**VILLAGE OF POMONA
BOARD OF PLANING MEETING**

Project Name: 85 Camp Hill Road

To: Village of Pomona Planning Board

TO: Village of Pomona Planning Board
FROM: Martin K. Spence, PE Village Engineer
DATE: March 11, 2026
RE: **85 Camp Hill Road Tax Map Reference 32.08-1-51**

NOTE - INSTALL 36" WIDE "ICE & WATER SHIELD" (OR EQUAL PRODUCT) AT ALL ROOF EDGES, IN VALLEYS, UP AGAINST WALL JUNCTIONS, OVER HIPS AND WRAP OVER ALL FASCIAS / ICE & WATER SHIELD TO COVER A MINIMUM 12" TO THE WARM SIDE OF EXT. WALLS

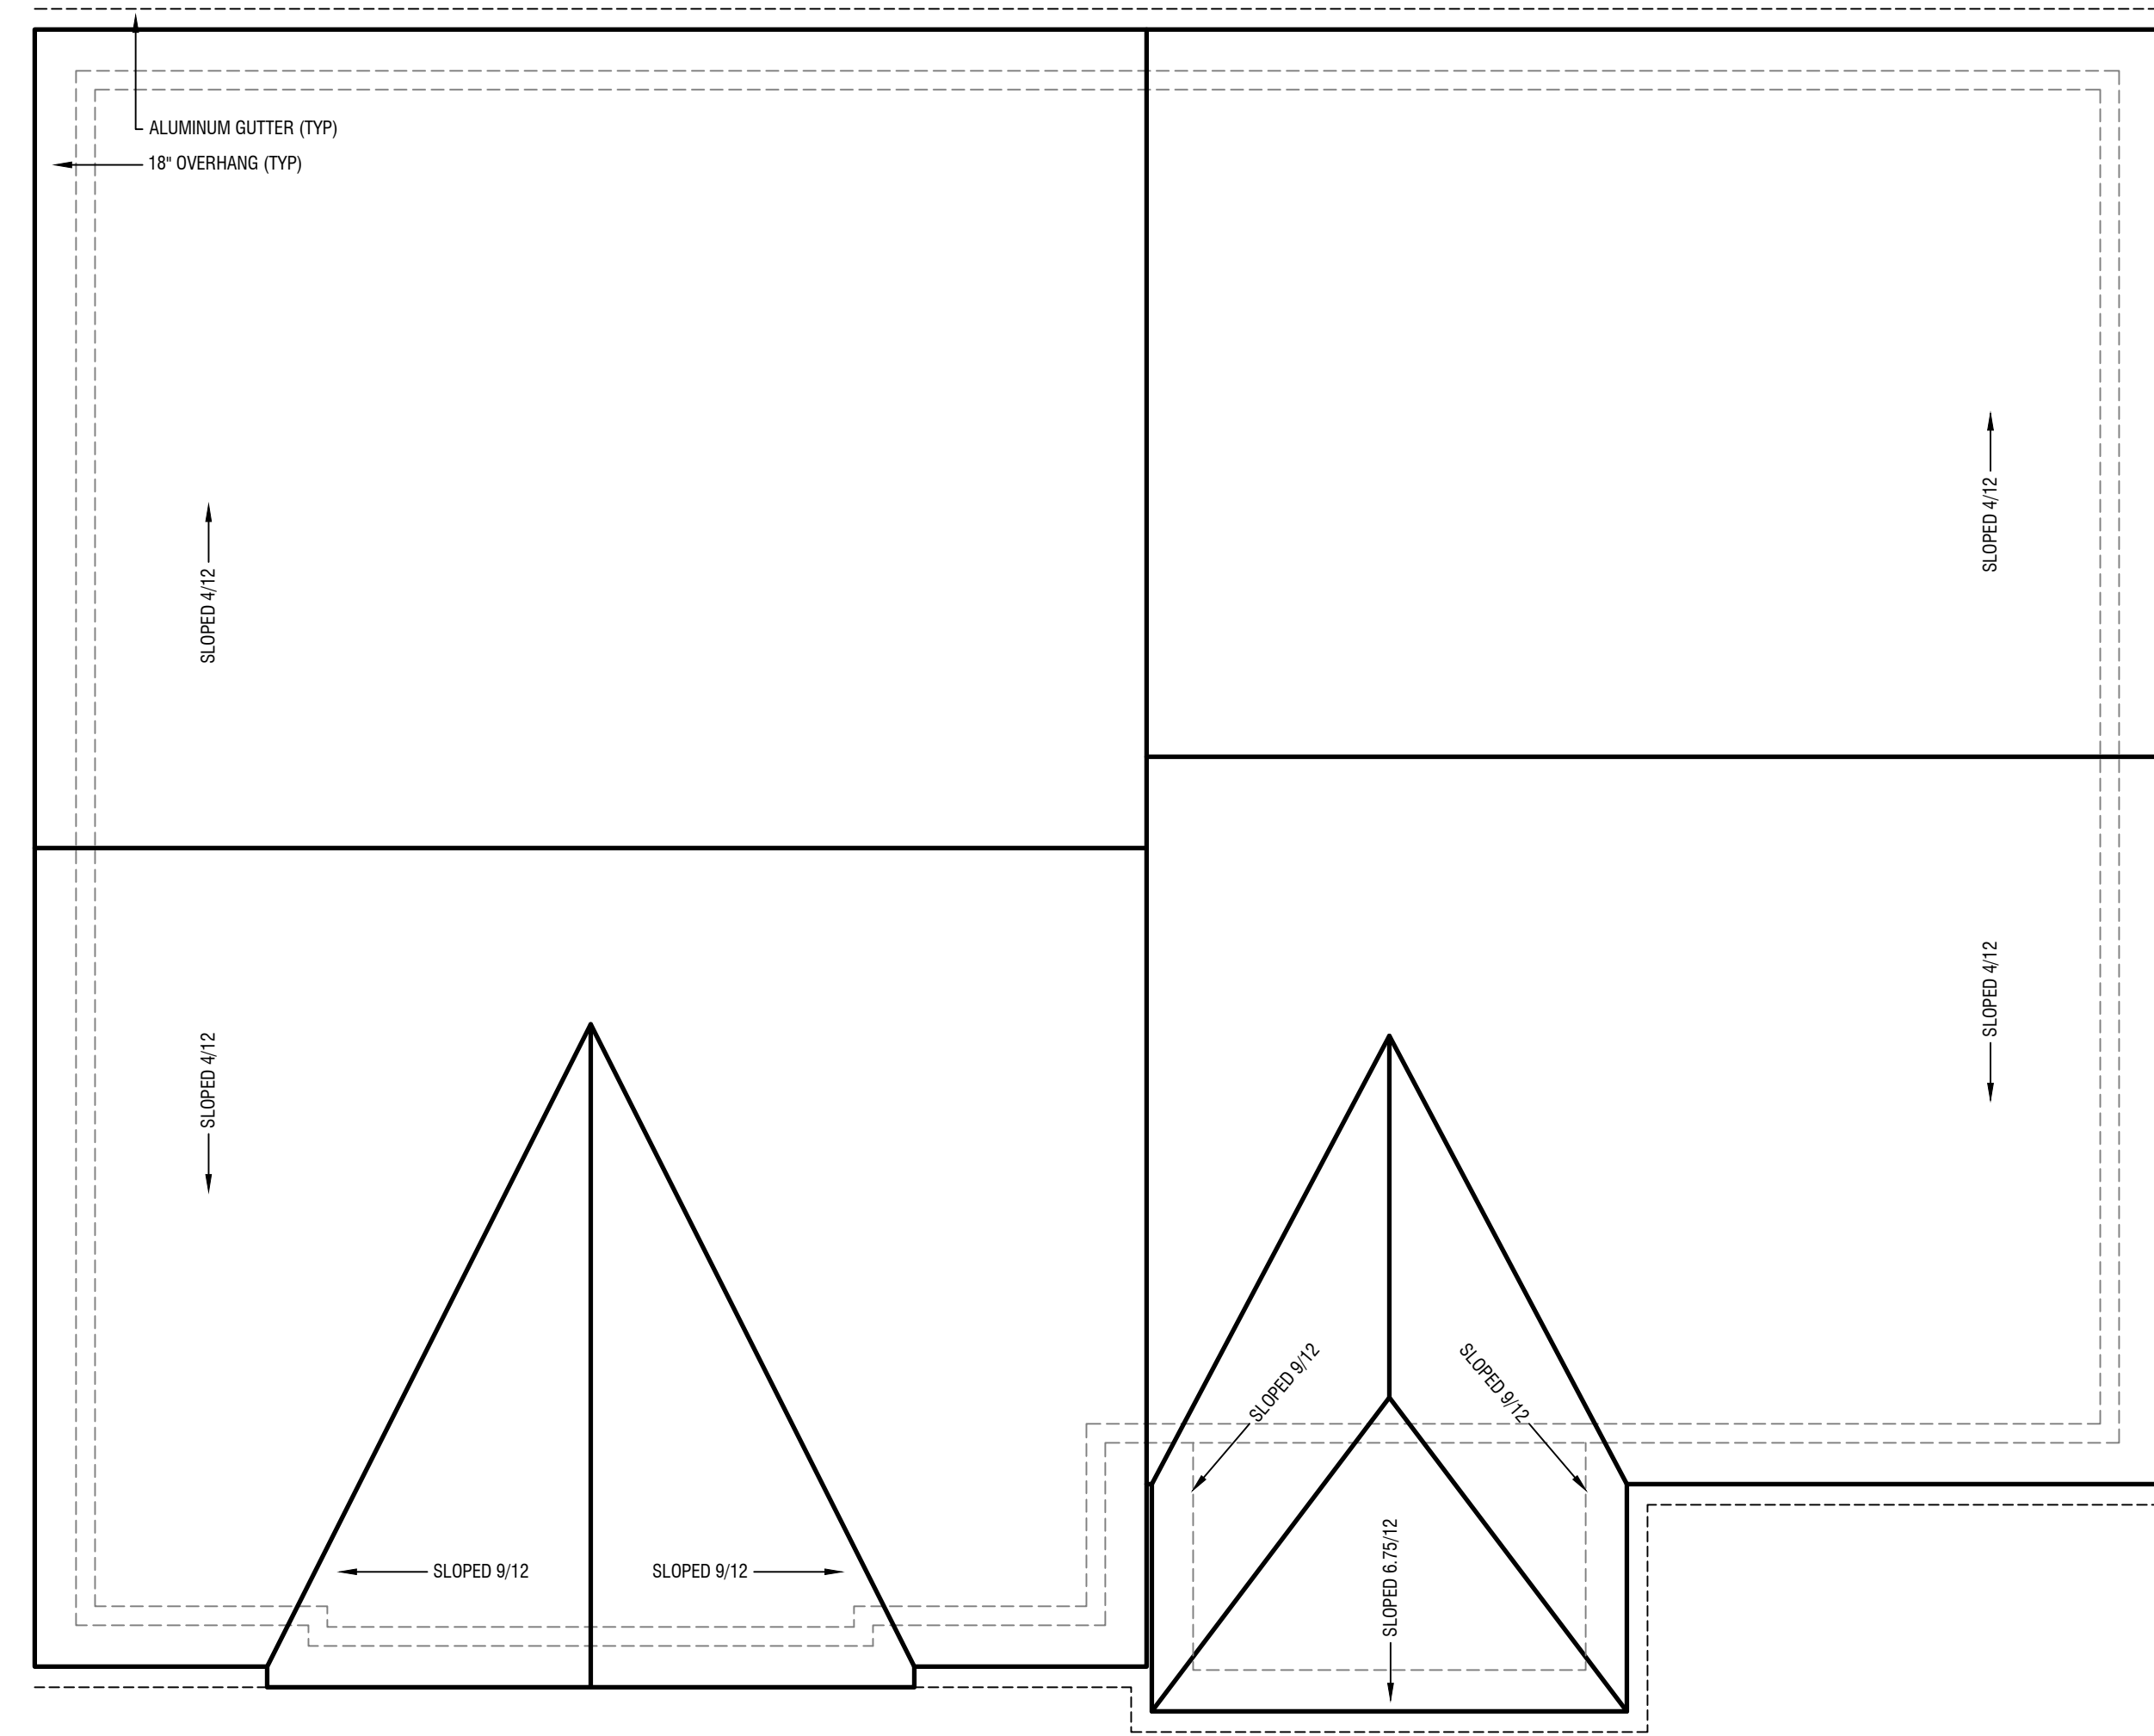
1. Please indicate the square footage for each floor of the structure proposed on sheets 3, 4 & 5 of the Architectural Plans. 10/2025 Not Addressed; **2/2026 Not Addressed**
